**ADDENDUM NUMBER: ONE**

**ISSUED BY: SEPW Architecture Inc.**  
109 – 3725 Pasqua St., Regina, SK. S4S 6W8  
PH. (306) 569-2255

**PROJECT: INPUT HOUSING, MITCHINSON & WAKELING  
HARBOUR LANDING, REGINA, SK.**

PROJECT NO. 10/2016	DRAWING NO. <b>A2.2R1</b>
DATE 2019-02-20	SCALE AS NOTED
DRAWN GE, GP	CHECKED DE

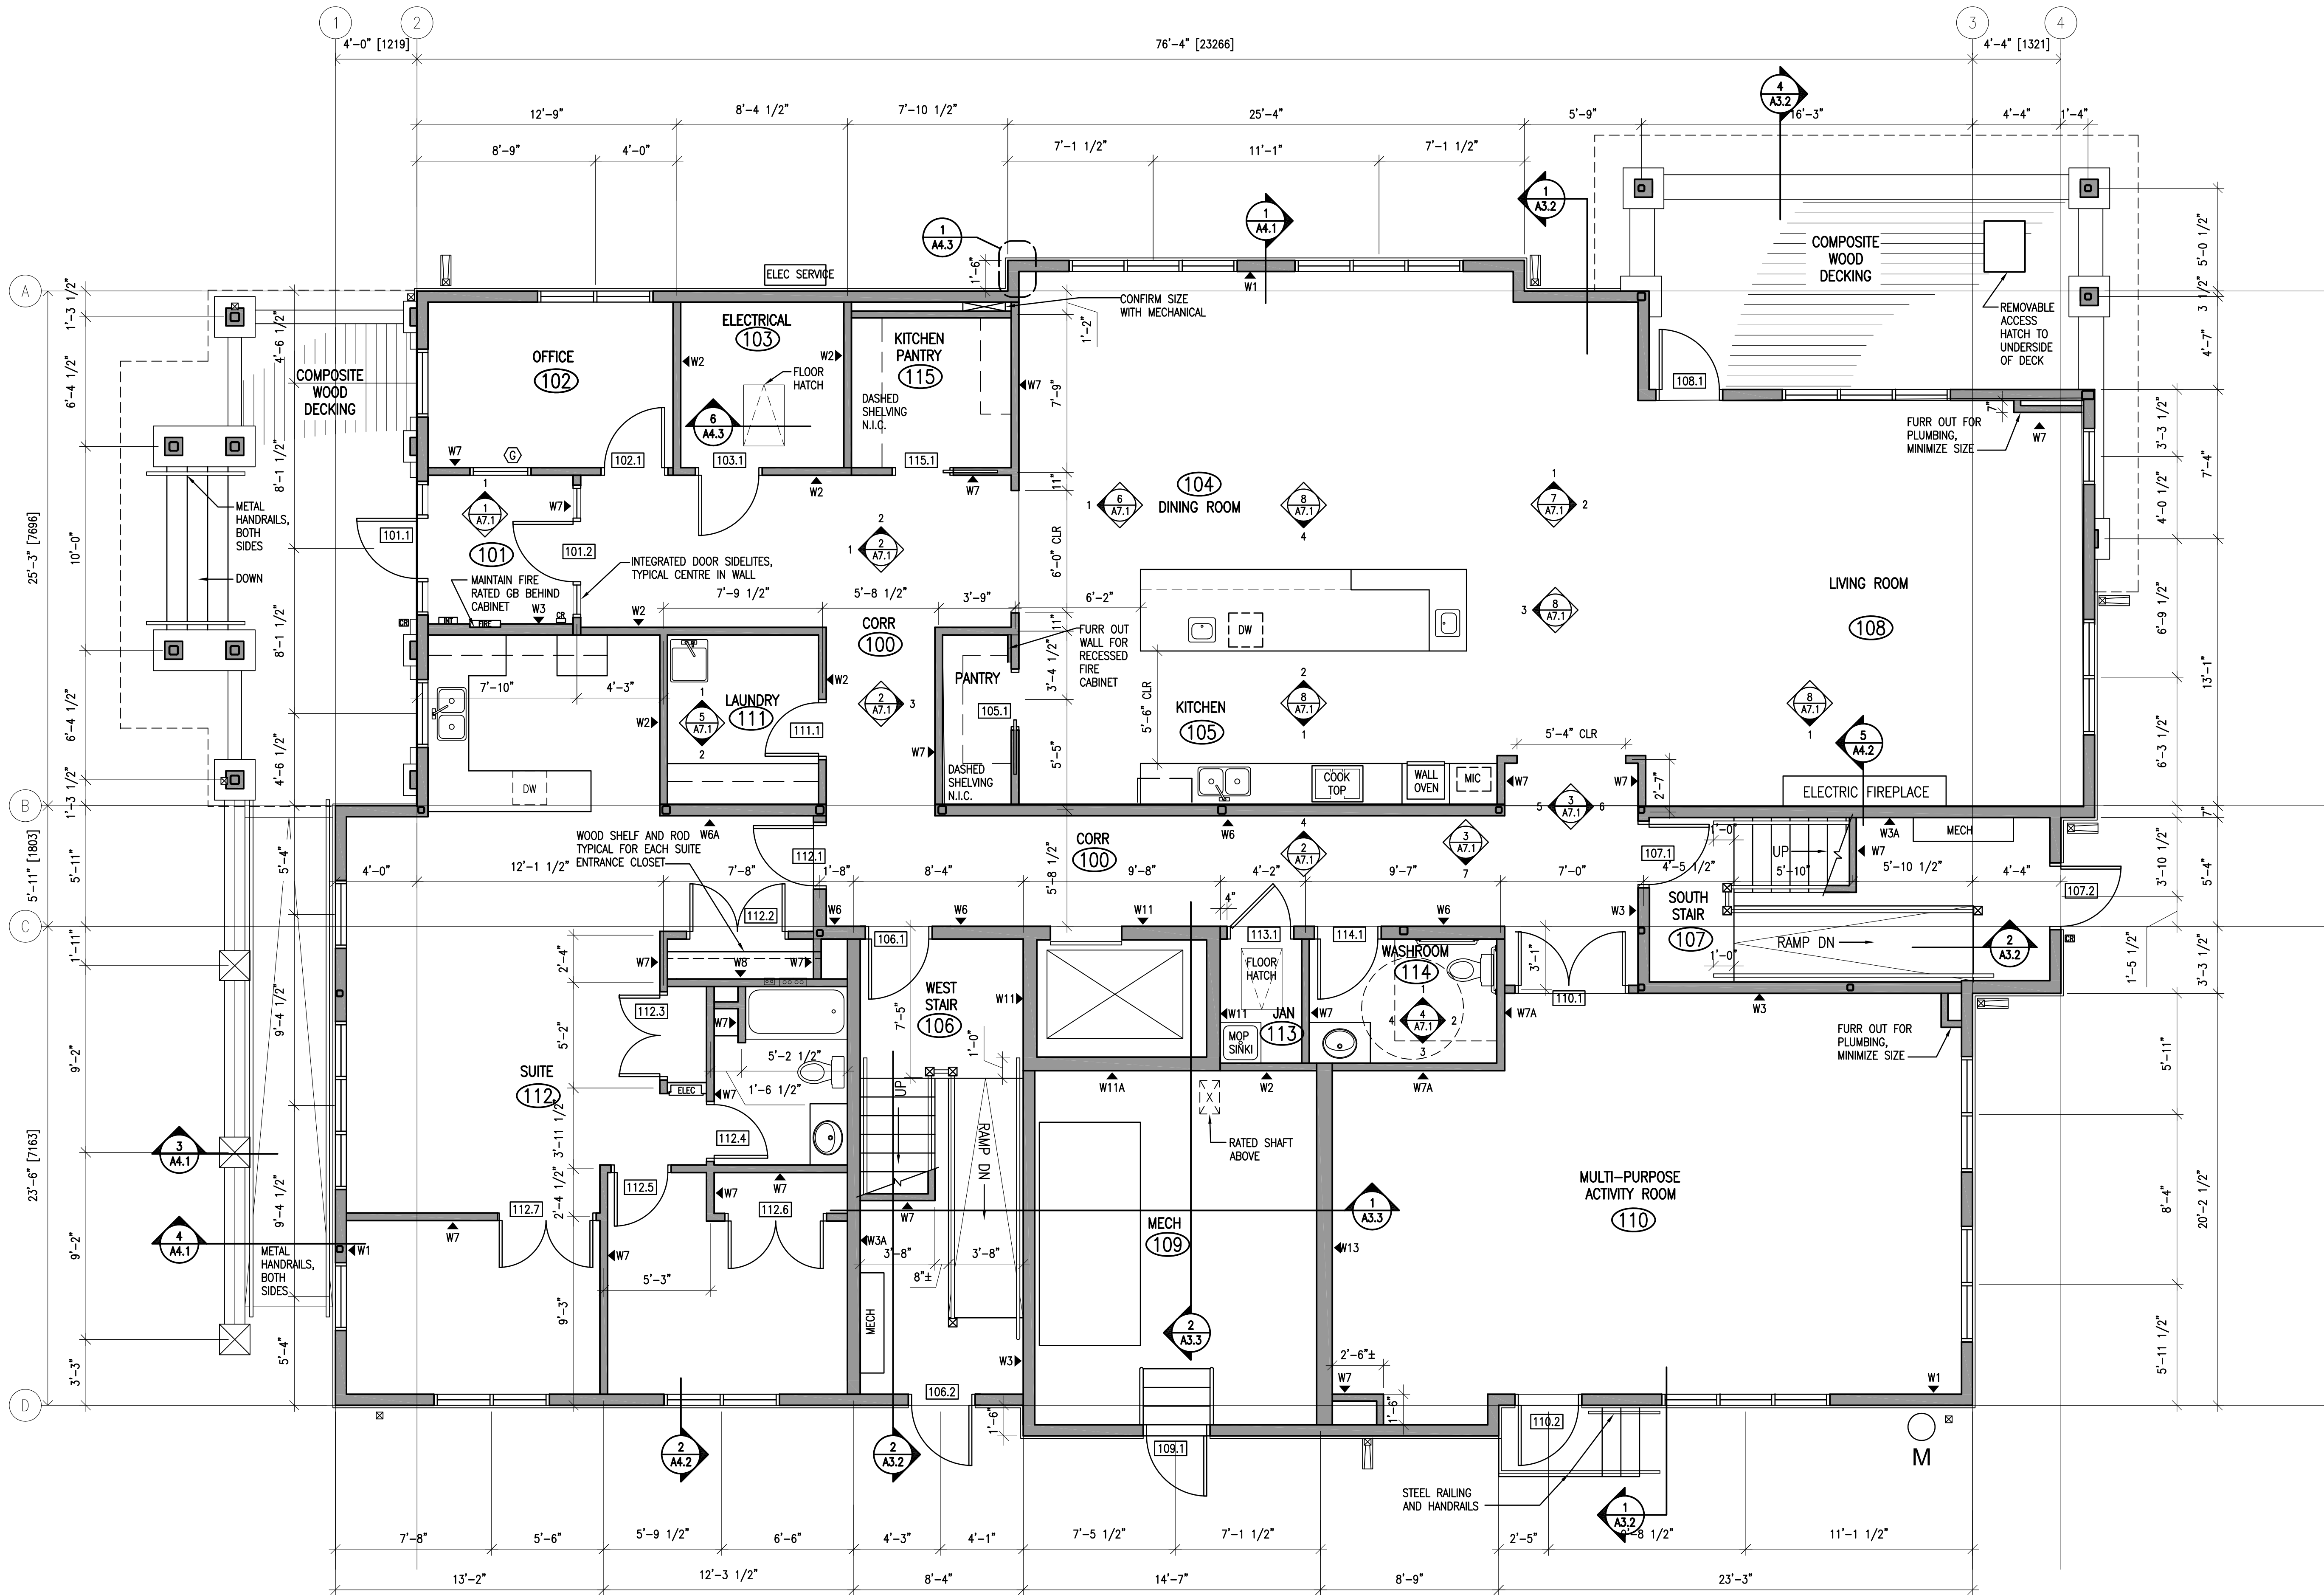
1. REPLACE drawing with 1/A2.2R1. Adds gridlines to floor plan.
2. REVISE in Appliances and Accessories: article 2.1, Undercounter dishwasher will be provided by owner and installed by General Contractor.
3. ADD in Appliances and Accessories: article 2.5 Electric Fireplace Dimplex “IgniteXLF74” linear fireplace or approved alternate. Dimensions 75.41”W x 16.49”H.

## PARTIAL PILE PLAN

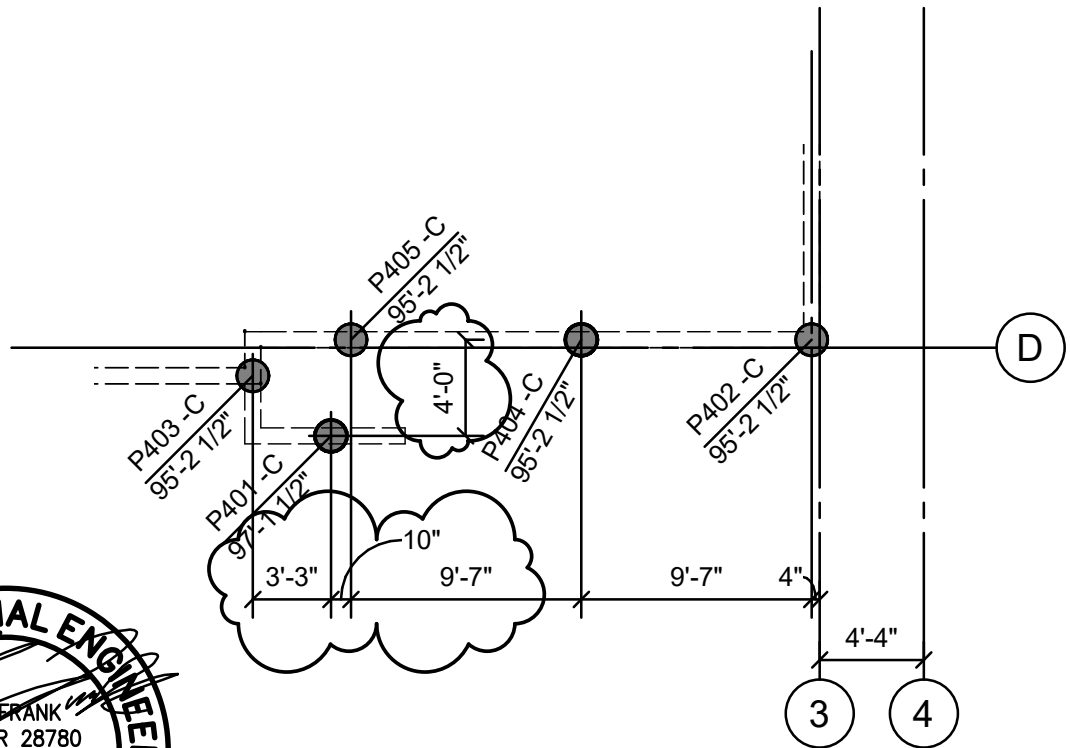
Pile Plan: Detail 1/S1. Revise location of pile under stair grade beam as per 1/SK2.

## EXTERIOR SLAB @ UPSTAND DETAIL

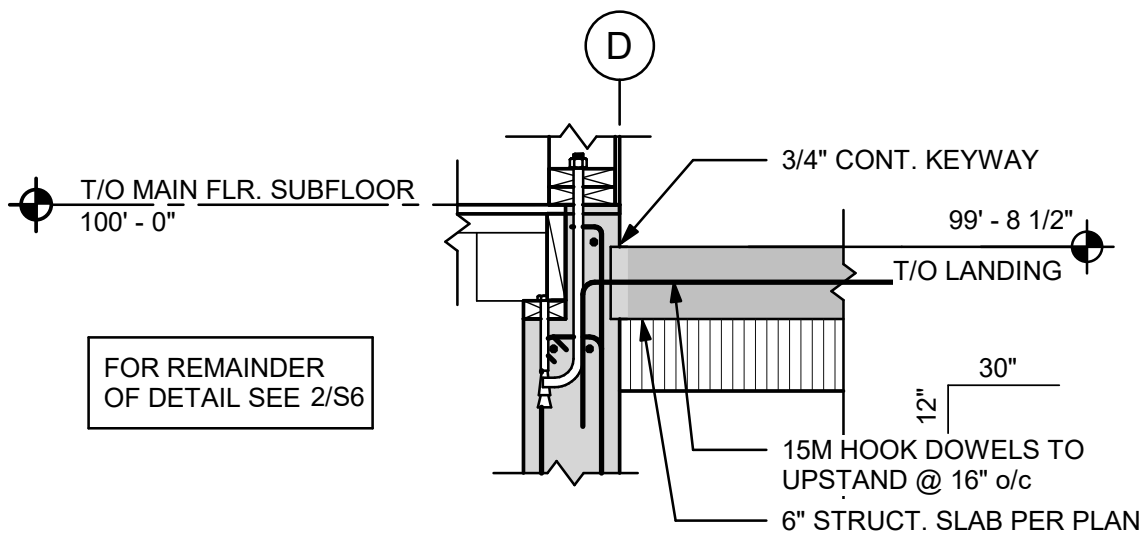
3. Drawing 4/S11 – Exterior Stair Plan: Replace plan detail with drawing 1/SK1.
4. Drawing 6/S11. Add Exterior slab at upstand detail as detail 6/S11. See attached detail 2/SK2

ADD AS DETAIL 6/S11
